UNITED STATES PATENT AND TRADEMARK OFFICE

APPLICATION NO.	FILING DATE	FIRST NAMED INVENTOR	ATTORNEY DOCKET NO.	CONFIRMATION NO.
09/940,034	08/27/2001	Mikhail Boroditsky	ATT-027PUS	4894

Office Action Summary

DETAILED ACTION

FIG. 5

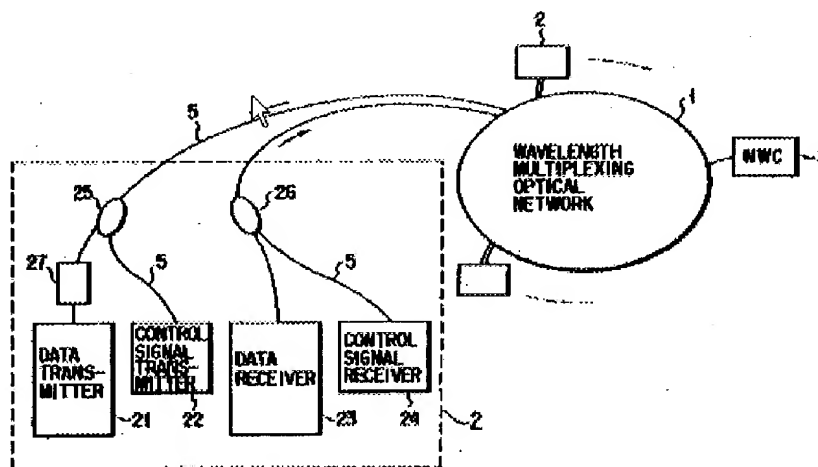
Re claim 1 Tomioka disclosed,

An optical packet-switched ring network (1 of Figure 5), comprising: a node including an optical switch (27 of Figure 5) coupled to a fiber of the ring network; a transmit switch (22 of Figure 5) coupled to the optical switch; a wavelength stacking assembly coupled to the transmit switch (); a receive switch coupled to the optical switch (21 of Figure 5); and a wavelength unstacking assembly coupled to the receive switch (e.g., col./line: 16/7-22).

FIG. 35

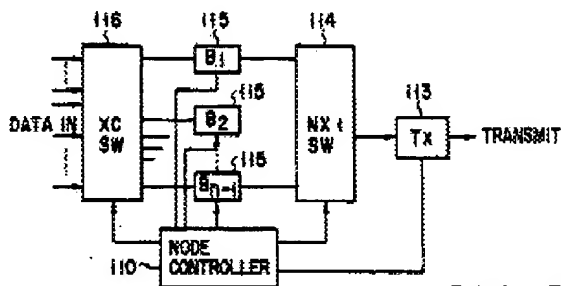
Re claims 4, 7 Tomioka disclosed,

A method for transmitting and receiving stacked packets on a ring network comprising: stacking packets of varying wavelengths (Figure 3) to form a composite transmit data packet; buffering the transmit data packet in a transmit switch (Bx of Figure 35); transmitting the transmit data packet onto the ring network via an optical switch; receiving a receive data packet via the optical switch; buffering the receive data packet in a receive switch (Bx of Figure 35); and unstacking the receive data packet (e.g., col./line: 16/7-22).
